**ADDENDUM NO. 2
MILLER CREEK ROAD IMPROVEMENTS
BRIGGS STREET TO MOCKINGBIRD WAY
February 5, 2010**

The following are amendments to the contract documents and plans for Miller Creek Road Improvements – Briggs Street to Mockingbird Way Project, Missoula, MT.

IRRIGATION DETAILS
MILLER CREEK ROAD IMPROVEMENTS
MISSOULA, MT

1500 GALLON PRECAST STEP TANK
HUNTON PRODUCT NO. 108
OR EQUAL
1500 GALLON SEDIMENT TANK
NO SCALE

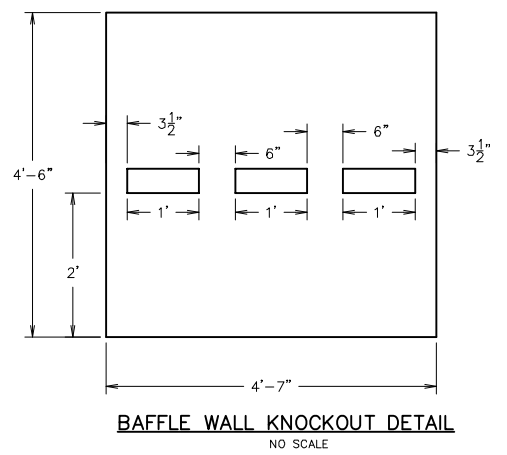
REVISE – Delete plan sheet 26 in its entirety and replace with the revised plan sheet 26 (attached). No changes to this sheet directly affect the bid form, however do note that the stilling well has been changed from a 30" diameter structure to a structure based on a 48" diameter manhole section. The 1500-Gallon Sediment Tank shall meet or exceed Hunton Product No. 108, including dimensions and wall thickness, contact Dave Hunton at (406) 543-8640 for product information.
